AQUIND INTERCONNECTOR

Applicant's Comments on Responses to ExA First Written Questions

Document Ref: 7.4.2

DATE: 20 OCTOBER 2020

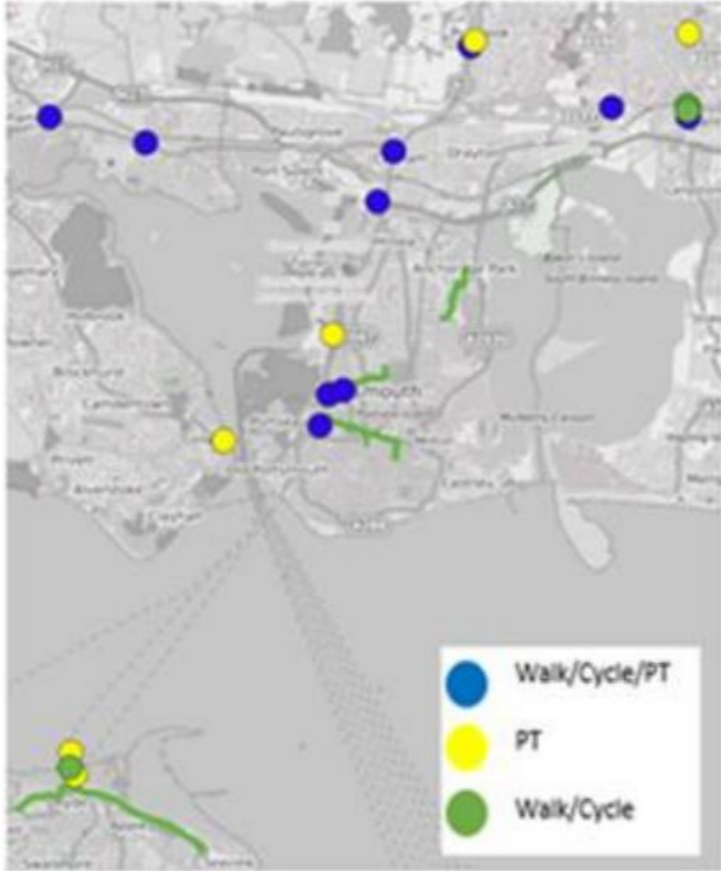
| Reference | Written Question | Response to Written Question | Applicant's Comment |
|-----------|---|--|--|
| | <p>The photography prepared to represent the views of the proposed Optical Regeneration Station buildings ([APP-285] to [APP-289]) is limited to summer views only. Does this represent an accurate and adequate worst case?</p> <p>How do these exclusions and matters sit with the Planning Inspectorate's Scoping Opinion [APP-366] at entry ID 14.13.2?</p> <p>Are there any relevant updates from the ongoing consultation that is being undertaken in this respect?</p> | <p>in Viewpoint 18 (Right): Wireline Summer Figure 15.52 D is deciduous.</p> <p>286 - The tree in Viewpoint 19: Baseline Summer Figure 15.53 A is deciduous and there would also be an element of dieback in the underlying vegetation.</p> <p>287 - Viewpoint 20: Baseline Summer Figure 15.54 A, save for comments about the tree on left hand side of photo, this is adequate.</p> <p>288 - With regard to Viewpoint 21: Wireline Summer Figure 15.55 B, a winter view may be required as clearly the car park was well used on the day the photograph was taken and as such the parked cars partially screen the view of the proposed building.</p> <p>289 - See above with regard to comments about the car-par and the deciduous tree in the middle distance, highlighted by an arrow</p>  <p>At entry ID 4.13.2 (not 14.13.2) - PCC would agree with the Inspectorate's conclusion that: 'The Scoping Report does not contain sufficient detail regarding the spatial and temporal nature of the proposed works associated with the landfall site, or the likely scale and significance of the acknowledged temporary effects, for the Inspectorate to agree that this matter can be scoped out of the ES. The Inspectorate notes the character area information including heritage assets within close proximity to the landfall site, as described in the Scoping Report. The ES should include an assessment of landscape and seascape character effects, including heritage assets, arising from the proposed landfall works, where likely significant effects could occur.</p> <p>None that PCC is aware of.</p> | <p>Please refer to the Applicant's Response at ExA WQ LV1.9.10 (REP1-091) in relation to the Planning Inspectorate's Scoping Opinion at entry ID 14.13.2 which explains that the assessment of landscape and seascape character was discussed and agreed verbally with PCC and that in order to focus on potentially significant effects, it was considered a study area of 300m was appropriate, and this should focus on landscape rather than seascape given the position of the Landfall relative to Eastney Beach and the built up nature of the surrounding area as well as the negligible impact associated with HDD up to the Landfall. The Applicant's response goes on to state that discussions are ongoing with PCC and Historic England, which include the production of another wireline from viewpoint 22 (REP1-141).</p> |
